SERVICE BULLETIN

M-937

1987 CRANK PIN, PINION SHAFT & BEARINGS

The purpose of this bulletin is to alert you to changes in the 1987 Service Manuals Engine Section and Service Bulletin M-927 regarding the new crank bearings.

Figure 2. Pinion Shaft Bearing Chart Color Code Changes

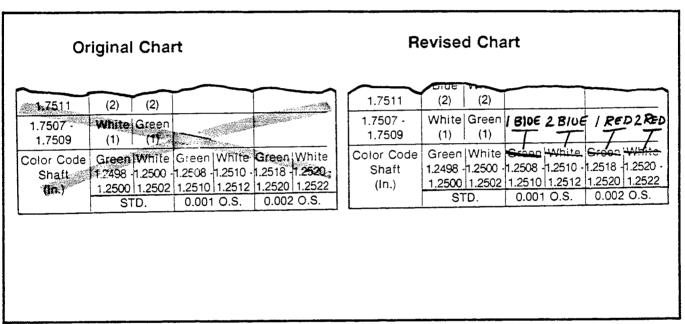
See Pinion Shaft Bearing Chart. The pinion shaft color codes for oversized shafts have changed as follows:

0.001 in. O.S. - 1 or 2 Blue paint dot(s)

0.002 in. O.S. - 1 or 2 Red paint dot(s)

See Figure 2. Revise the chart and text to show this change.
